Other Regulations – Regulation No. 112 (Headlamps emitting an asymmetrical passing-beam)

Proposal for a corrigendum to the 01 series of amendments to Regulation No. 112

Submitted by the expert from France*

Annex III, Figure B, correct as follows (in blue):

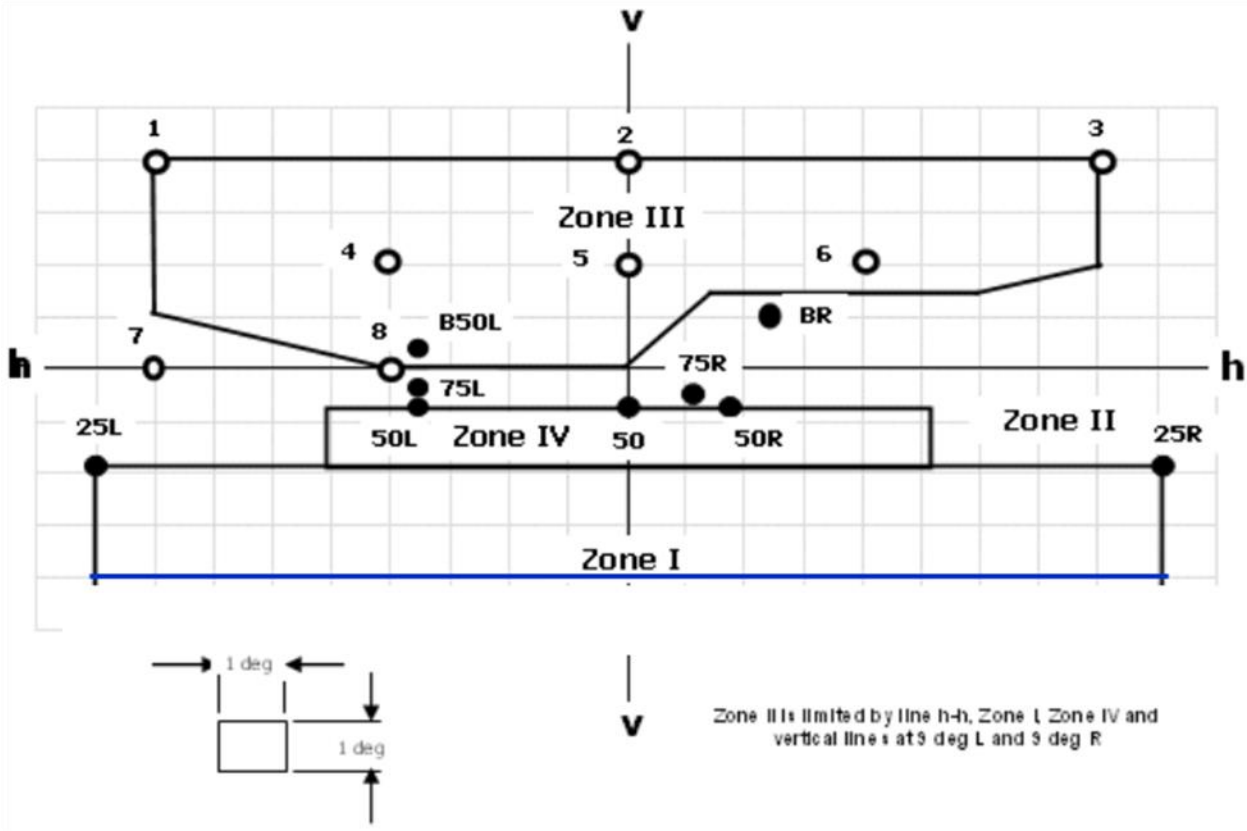
2. The angular limits of ZONE I are 1.72D to 4D vertically and 9L to 9R horizontally. However, in the figure B in Annex 3, the lower limit of zone I is at 5°D. We propose to correct this inconsistency which appears in 01 series of amendments in the drawing.
